July 20, 2026 File No. 4063

Re: Urban Design Brief Addendum – Stages 3 and 4, Barrel Yards Development

GSP Group Inc. has prepared this Urban Design Brief Addendum on behalf of Silver Lake Developments Inc. in support of the Official Plan Amendment and Zoning By-law Amendment applications for the revised development for Stages 3 and 4 of the Barrel Yards development in the City of Waterloo.

Figure 1: Ground Floor Plan – Erb Street West Frontage

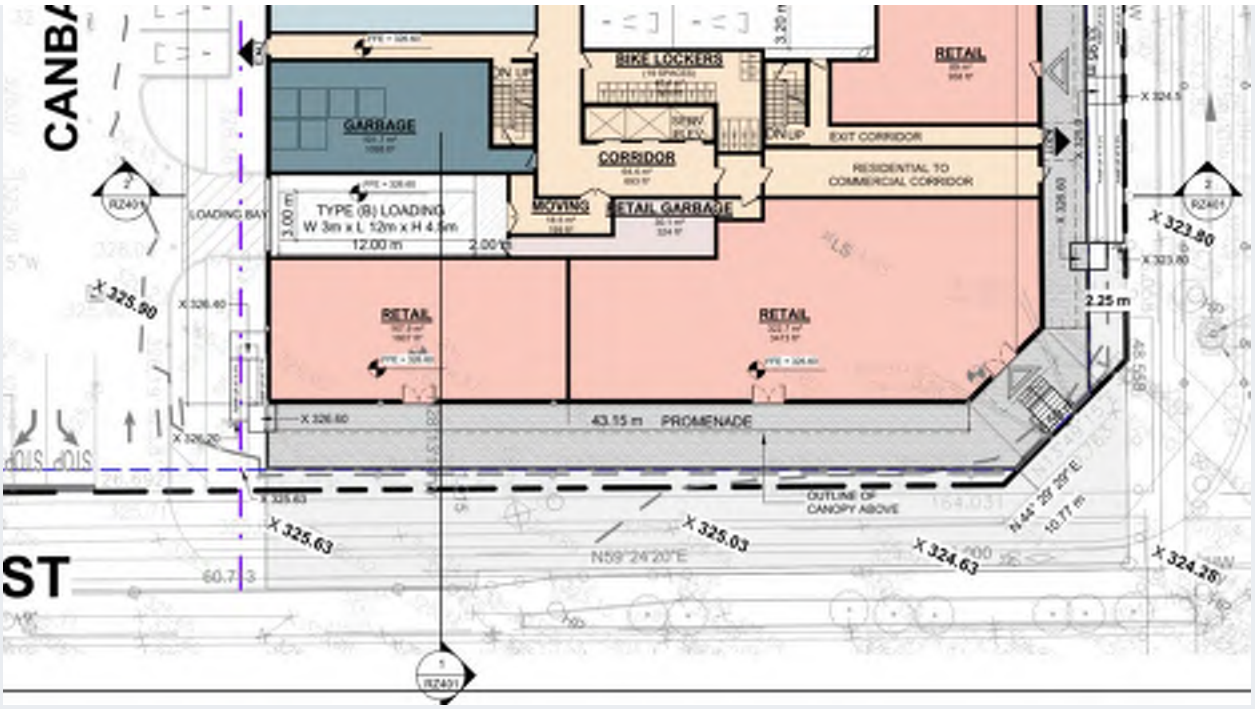
Comment 15 – Wall Height Along Erb Street West

Comment 26 – Elevated First Floor and Retail Visibility

Elevated first floor creates separation between the retail and public realm which eliminates clear visibility between the two. A grade change, even of this small amount will reduce the vibrancy of this frontage as an active streetscape.

The concern appears to arise from the interpretation of Section 2 on Drawing RZ401 of the architectural drawing set, rather than the section applicable to the Erb Street West frontage. The section relevant to the Erb Street West frontage is Section 1 on Drawing RZ401, not Section 2. Section 2 is taken through the building in the direction of Father David Bauer Drive and does not represent the grade relationship along Erb Street West. Please refer to Figures 1 and 2 for reference.

Section 1 on Drawing RZ401 illustrates the relationship between the Erb Street West sidewalk, the promenade, the retail frontage, and the required regulatory flood elevation. Along this frontage, the existing street grade falls by approximately 1.35 metres toward the intersection, with the lowest elevation occurring at the corner of Erb Street West and Father David Bauer Drive. Accordingly, the grade difference is not uniform along the frontage and is greatest near the corner.

The retail units open directly onto the continuous promenade, which extends along the Erb Street West frontage and provides access to the commercial entrances. The proposed condition should therefore not be interpreted as a continuous retaining wall measuring 2.4 metres in height.

The elevated ground-floor and retaining-wall conditions are also supported by the Stage 4 Flood Risk Assessment prepared by Stantec. The Assessment confirms that the occupied finished-floor elevation is set at 326.60 metres, above the regulatory flood elevation throughout the site, and that the retaining wall along the east and south sides forms part of the passive floodproofing strategy. The grade relationship therefore reflects the regulatory flood-protection requirements applicable to the site rather than a discretionary elevation of the commercial frontage.

The Stage 4 Flood Risk Assessment confirms that the proposed finished-floor elevation is above the regulatory flood elevation throughout the site. The commercial, common and residential entrance areas must therefore remain at this elevation to provide passive flood protection and cannot be lowered to match the adjacent sidewalk.

Figure 2: Building G South Elevation

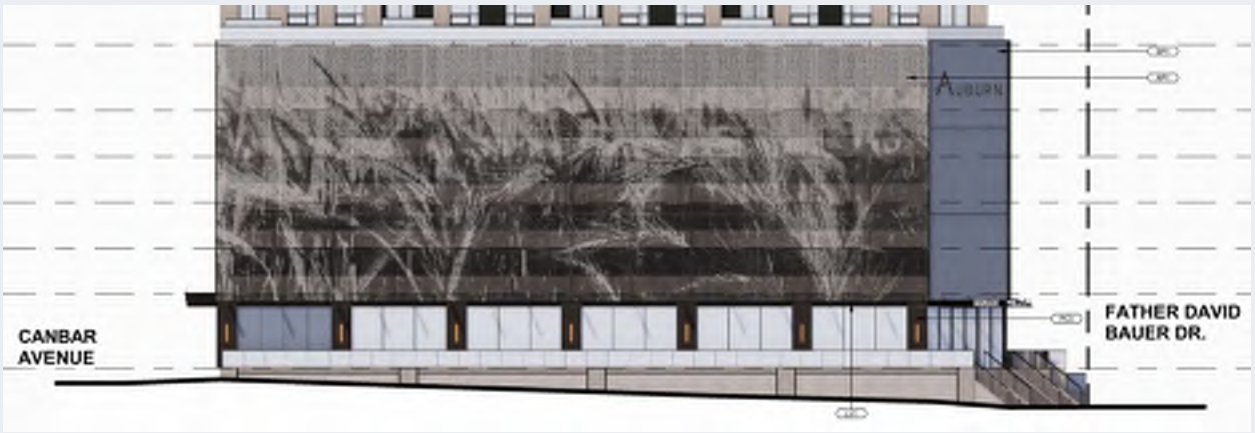
Comment 29 – Southern Elevation of Building G

Staff's concern regarding the southern elevation of Building G appears to be influenced, in part, by the same misinterpretation of the submitted cross-sections identified in the response to Comment 15. The approximately 2.4-metre retaining-wall condition referenced by Staff does not occur along the Erb Street West frontage.

The relevant condition is illustrated in **Section 1 on Drawing RZ401**, which shows the relationship between the Erb Street West sidewalk, the continuous promenade, the retail frontage and the regulatory flood elevation. Please refer below for the elevation along Erb Street West.

The tower elevation incorporates recessed façade areas, balcony projections, vertical architectural elements, material transitions, reduced upper floorplates and stepbacks. These measures provide depth and visual interest and avoid the appearance of a flat slab end facing Uptown. Accordingly, the southern elevation is intended to function as a fully resolved public-facing façade that contributes to the prominence of the intersection and the approach toward Uptown Waterloo.
